WPPSS QUALITY CLASS I, II & G

WASHINGTON PUBLIC POWER SUPPLY SYSTEM
 NUCLEAR PROJECTS NO. 385
 480V-480V INSTALLATION
 480V MOTOR CONTROL CENTER DATA SHEET
 480V MOTOR CONTROL CENTER A313, B313 & A231

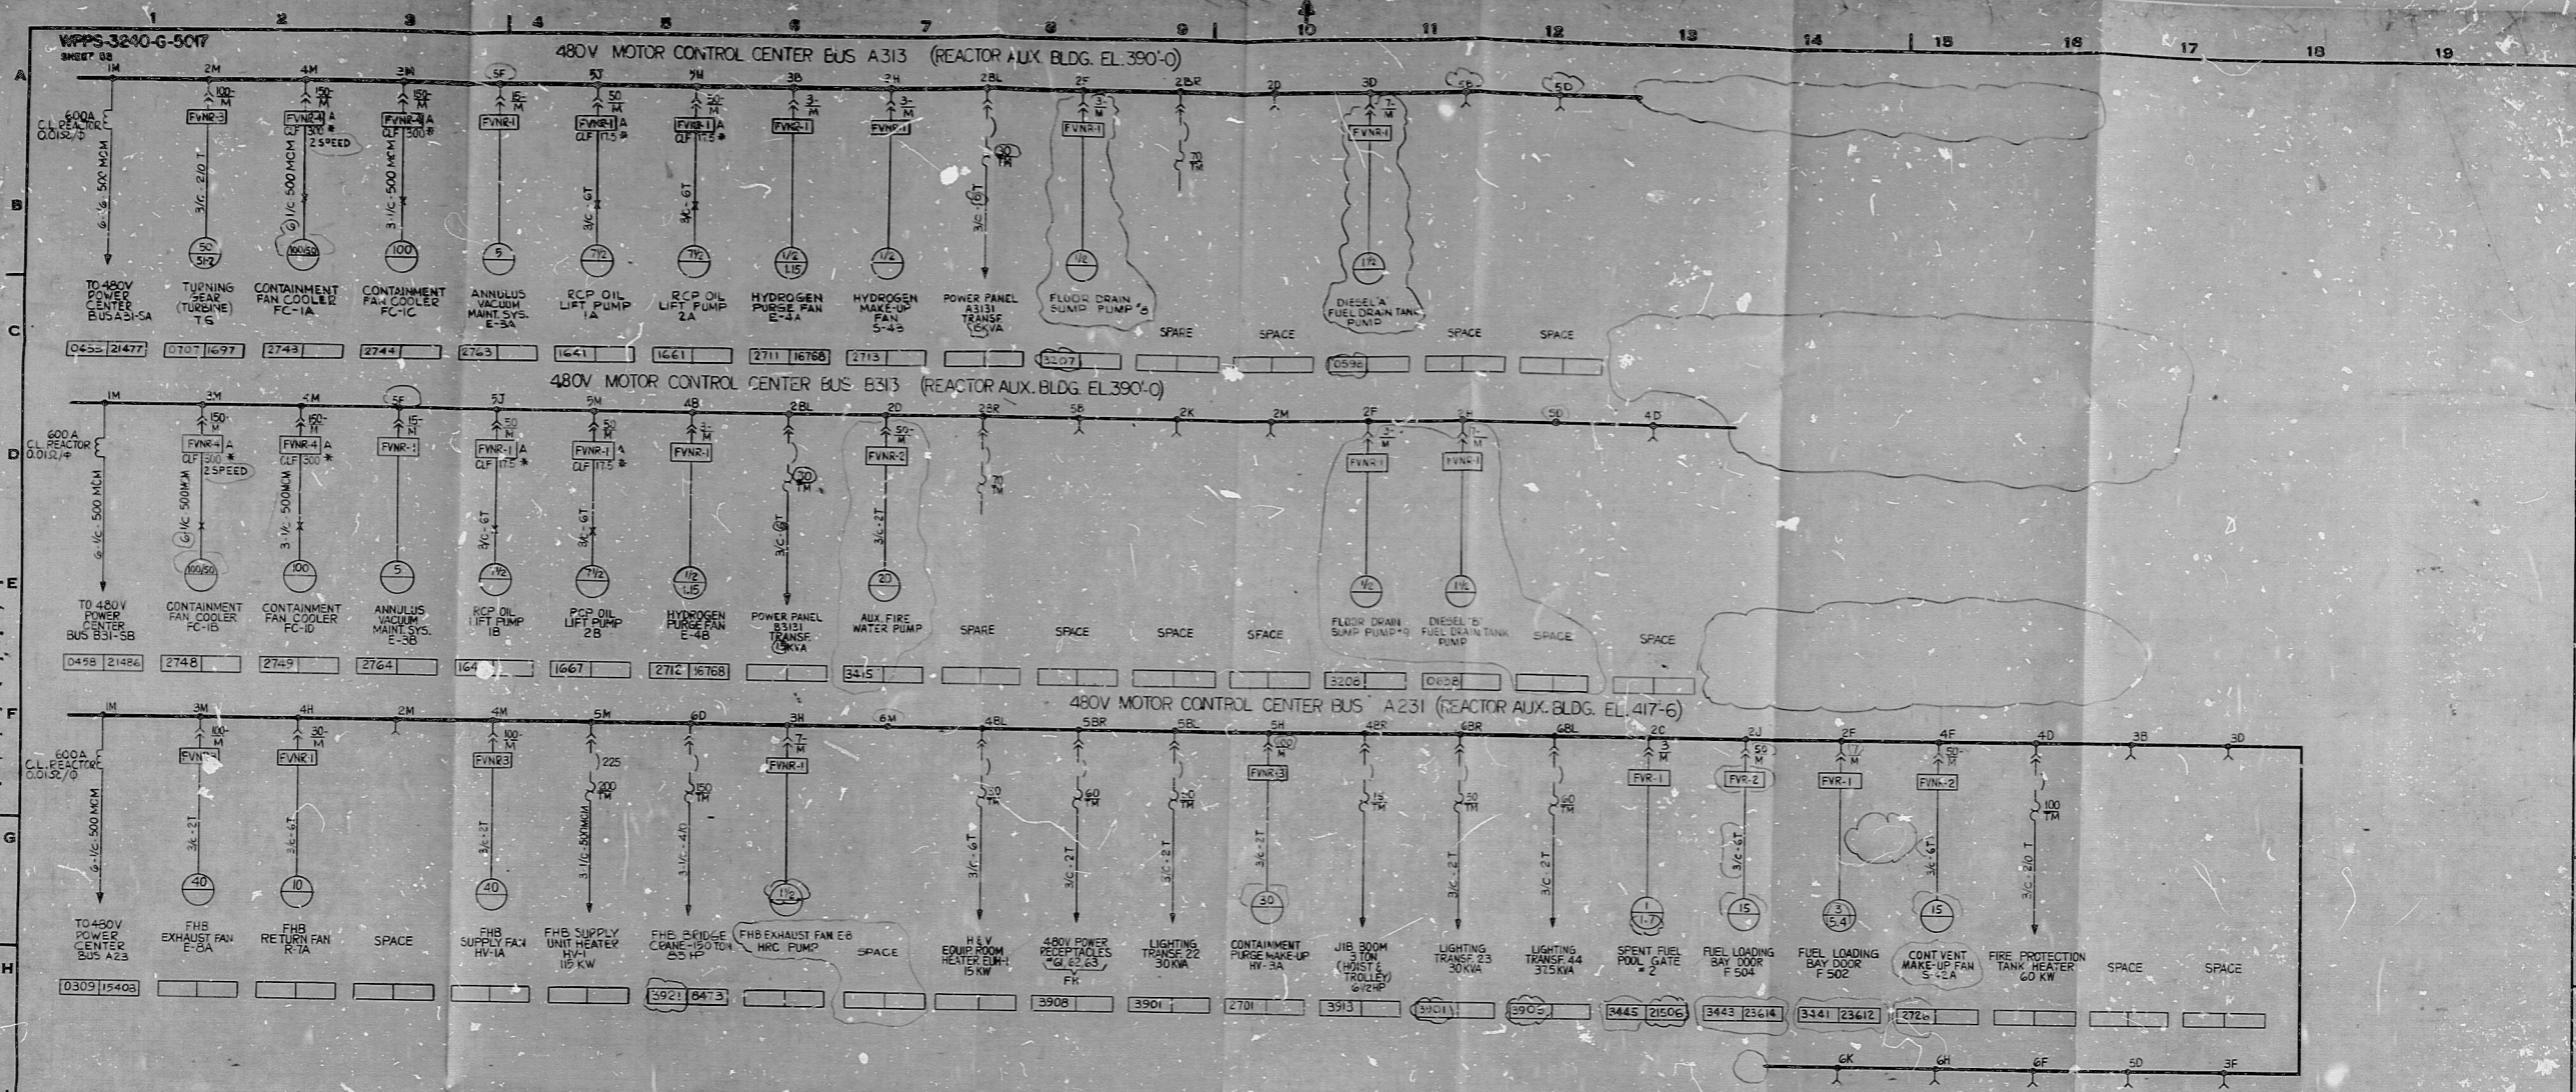
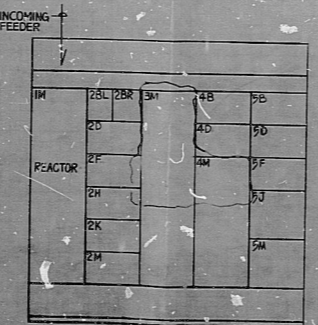
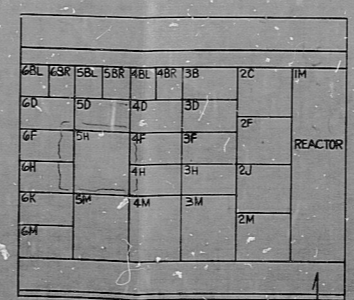
ADDED: 480V (E7, E1) MOTOR STARTERS CWD EMDRAC REF DWGS AS CIRCLED
 DELETED: CAPTIONS (A) THROUGH (M) IN THE CWD'S; NOTE RELEASED; NOTE REWIND; 480V EQUIP DATA TABLES; 480V MOTOR DATA; COMP. NOS. AS CIRCLED; S.L.T. LIP FRONT VIEW.

3 14-20-82
 RELEASED: MCC A231
 ADDED: CWD EMDRAC REFERENCE DWGS; MOTOR DATA AS CIRCLED
 DELETED: (E7, E1) STARTERS
 REVISED: FRONT VIEWS AS CIRCLED; MINOR DIMENSIONS
 2 11-8-79
